### 3.0 LIMITING CONDITION FOR OPERATION (LCO) APPLICABILITY

STP DEP 16.3-1

The information in this section of the reference ABWR DCD, including all subsections, is incorporated by reference with no departures and the following site-specific supplement. This site-specific supplement partially addresses COL License Information Item 16.1.

**Figure B 3.3.1.1-1 ADS Inhibit Instrumentation Channels**

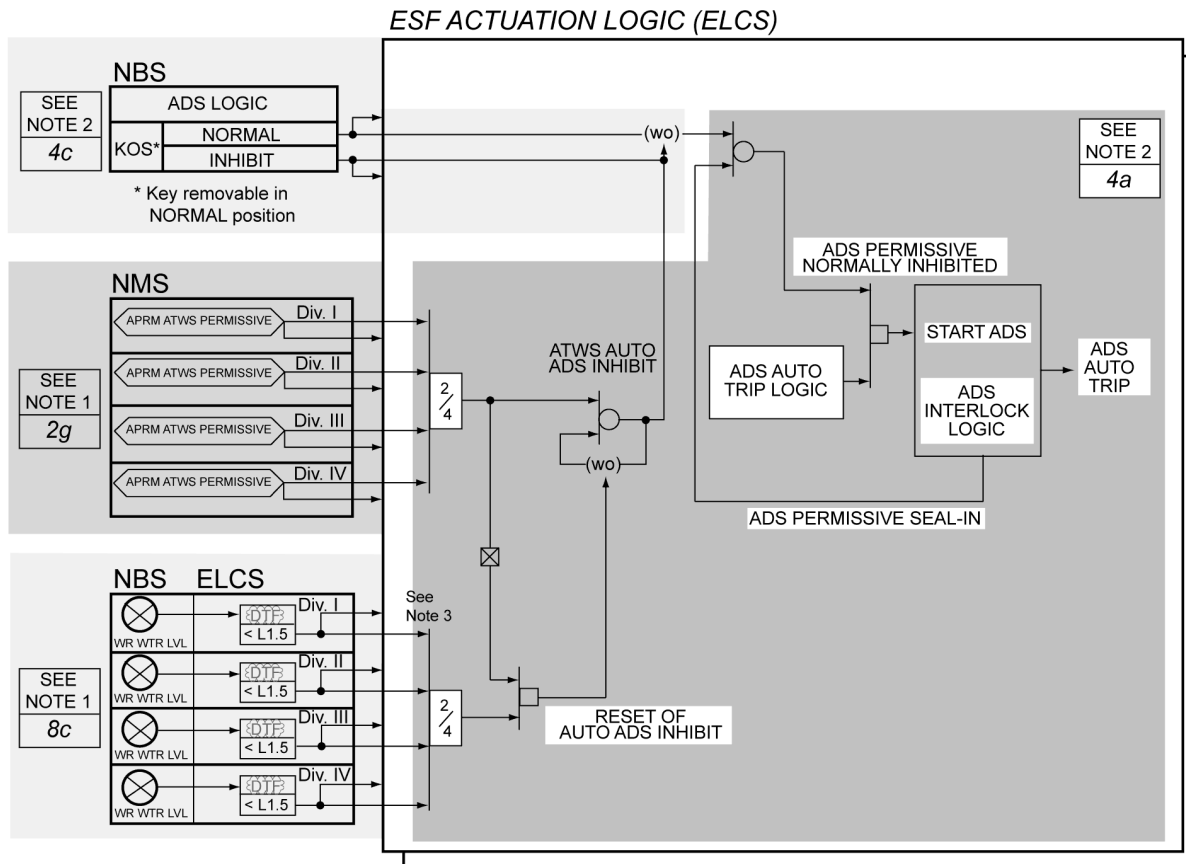
STD DEP T1 3.4-1

**Figure B 3.3.1.1-2 RCW/RSW HX Room Leak Detection Instrumentation Channels**

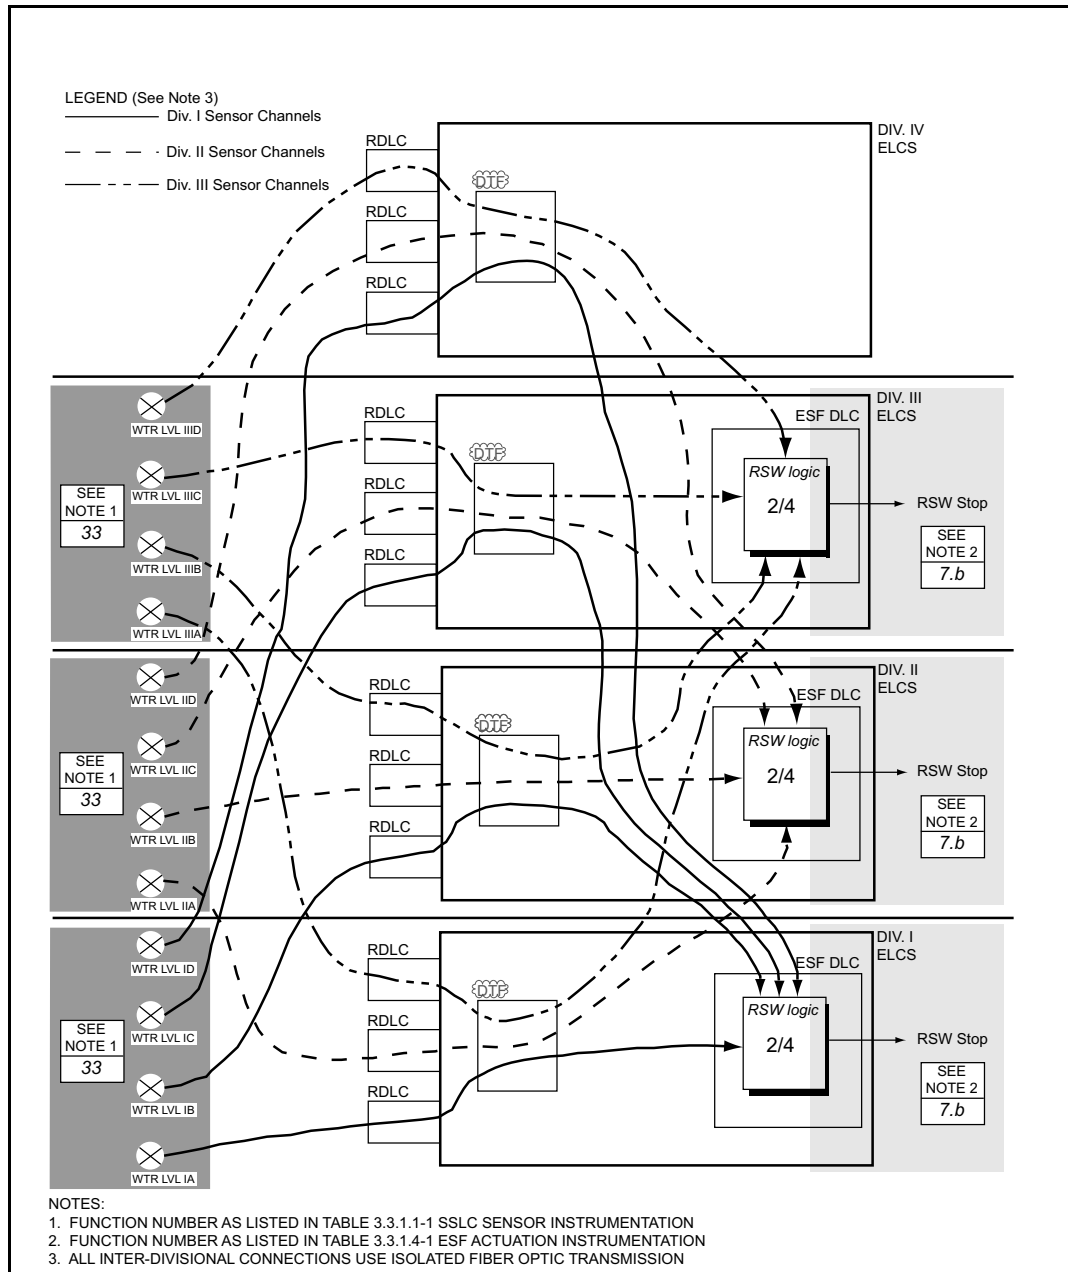
STD DEP T1 3.4-1

**Figure B 3.3.1.4-1 ESF Actuation Channel Structure for Containment Isolation, ESF Support**

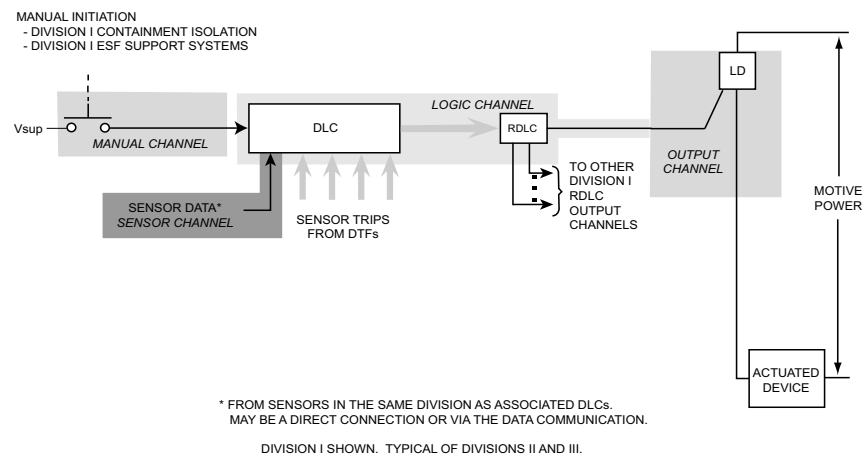
*The channel structure for the channel types covered by this LCO are depicted in Figures B 3.3.1.4-1 through B 3.3.1.4-45. The channel structure in these Figures is similar with the basic structure as shown in Figure B 3.3.1.4-1. The channel characteristics shown in the ~~Figures Figure B-3.3.1.4-1~~ are:*

STD DEP T1 3.4-1

**Figure B 3.3.1.4-2 ESF Actuation Channel Structure for LPFL B, C, HPCF B, RCIC**

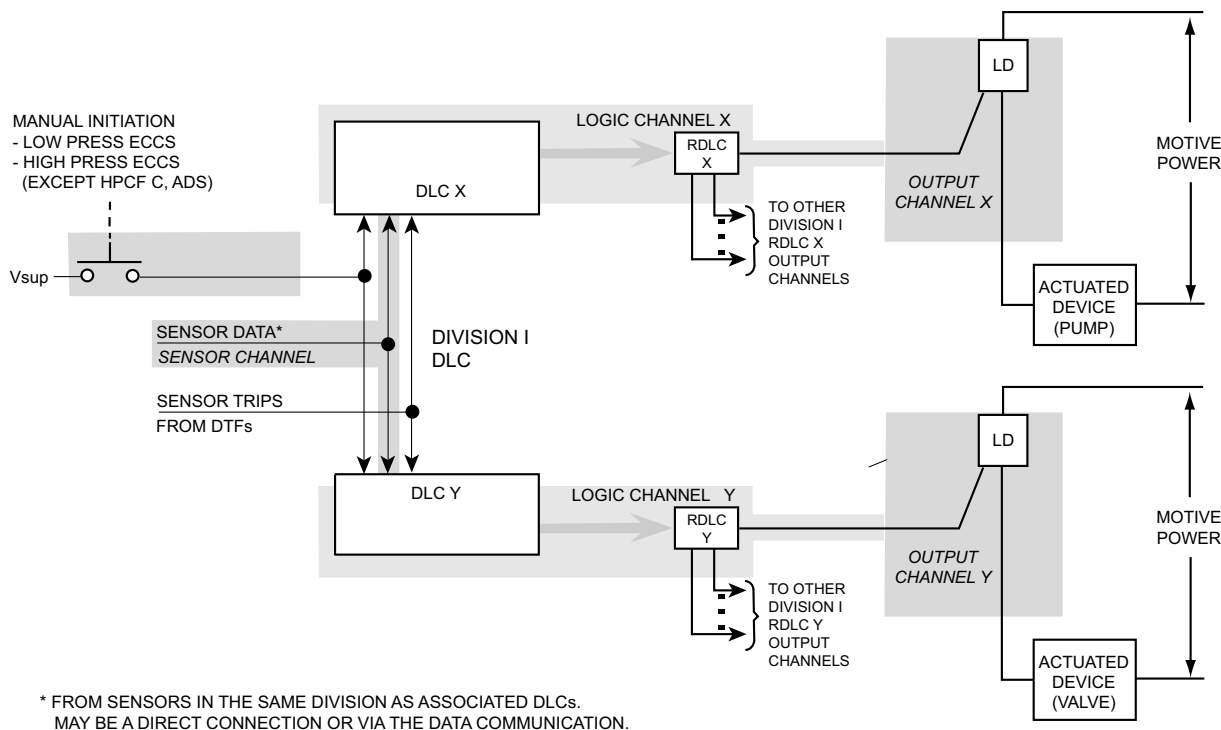
STD DEP T1 3.4-1

Figure B 3.3.1.4-3 ESF Actuation Channel Structure for HPCF C

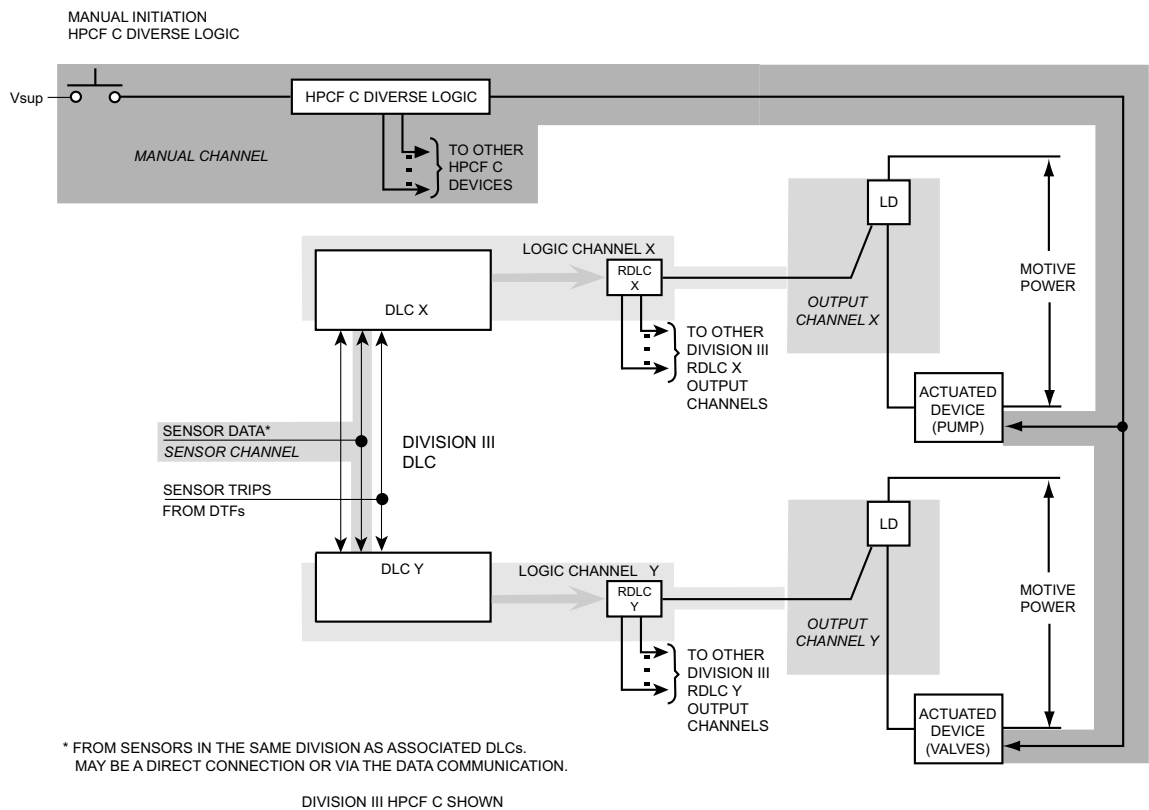
- Each of the redundant ~~DLCs SLU pairs~~ is considered to be a separate LOGIC CHANNEL although they originate within the same division.
- Figure B 3.3.1.4-3 shows the hardwired manual channel for HPCF C diverse logic which applies only to division III.

STD DEP T1 3.4-1

Figure B 3.3.1.4-4 ESF Actuation Channel Structure for ADS

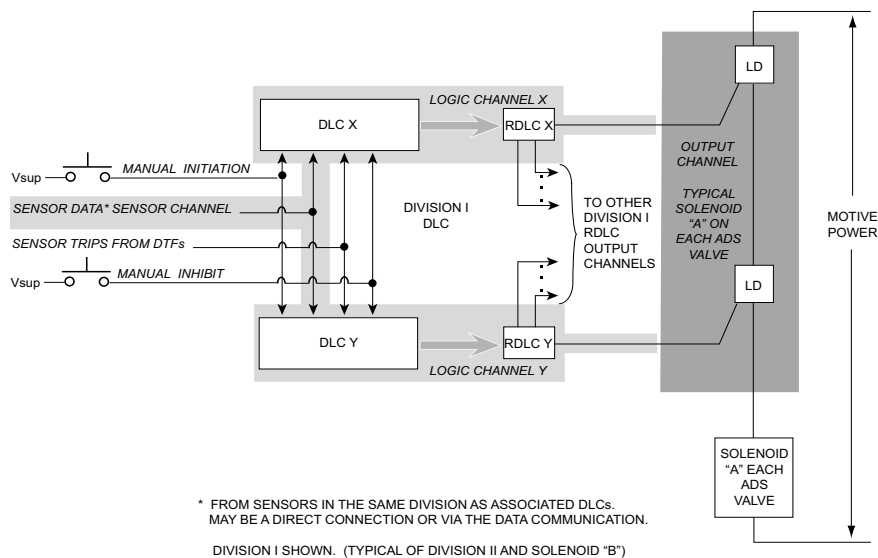
The ATWS Manual ADS Inhibit push button channels introduce signals into the ADS logic to provide manual ADS inhibit capability that is redundant to the automatic SENSOR CHANNELS. There is one push button for each ADS division trip system. ~~Each pushbutton has two contacts. Each member of the SLU pair~~ Both DLCs used to implement ADS within a division acquire data from ~~one of the contacts on the switch in its division~~ (see Figure B 3.3.1.4-4).

STD DEP T1 3.4-1

Figure B 3.3.4.1-1 ATWS and EOC-RPT Instrumentation Channels

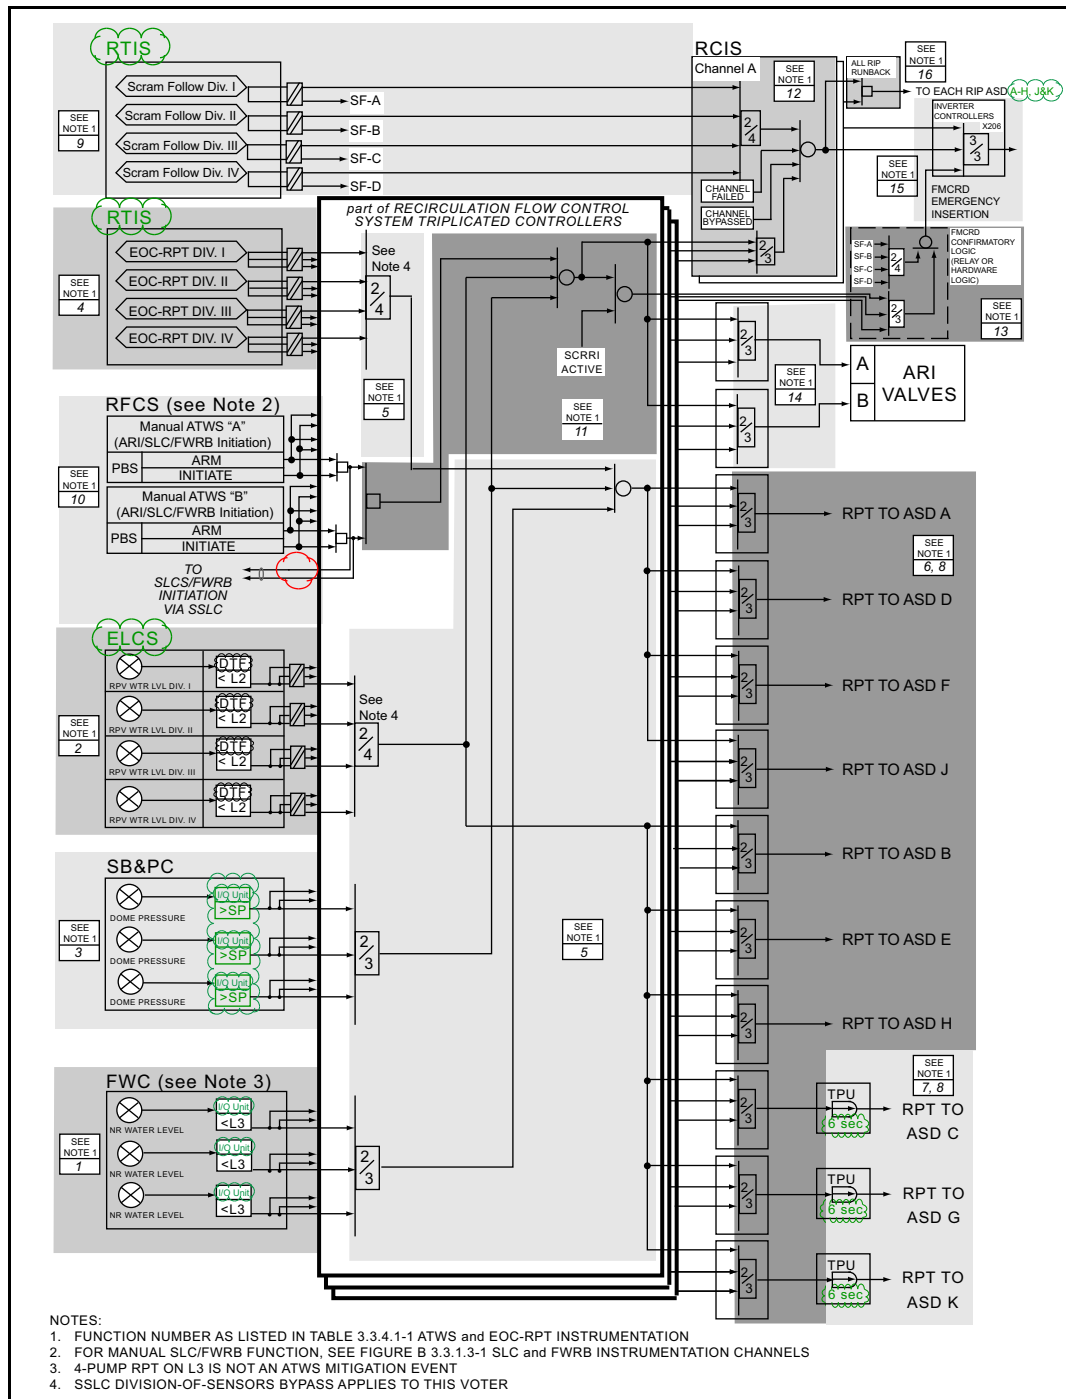
STD DEP T1 3.4-1
